RE: NEWCASTLE INNER CITY BYPASS

Outlined in this letter is a submission by the owners of 3A Marshall Street, New Lambton Heights, in response to the exhibited EIS for the Newcastle Inner City Bypass. This submission is to outline our objections to the proposal to construct a large filled batter on the neighbouring RMS owned land and property at 1A Marshall Street New Lambton Heights. Construction of this batter is proposed as part of the Southern Interchange Works.

Figure 1: Marked up excerpt from Figure 5.1EIS Technical Paper 4 Visual Impact Assessment

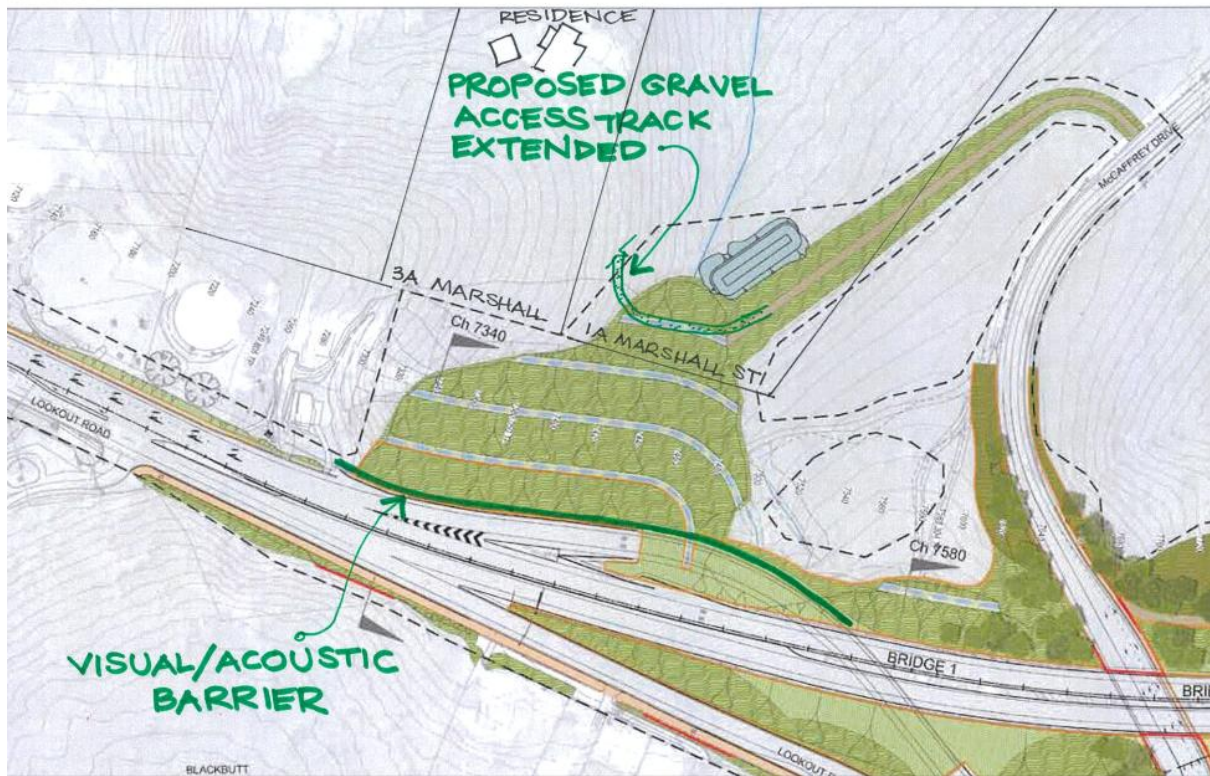
2. The batter design is amended to widen the lowest vegetation swale to continue the gravel access track to allow access from the north east corner of our property, as shown on the attached mark-up of the Visual Impact Assessment drawing showing the area.

3. That a sound/visual barrier be constructed along the side of the Bypass to ensure that road noise levels do not increase after construction of the Bypass, also as shown on the enclosed drawing.
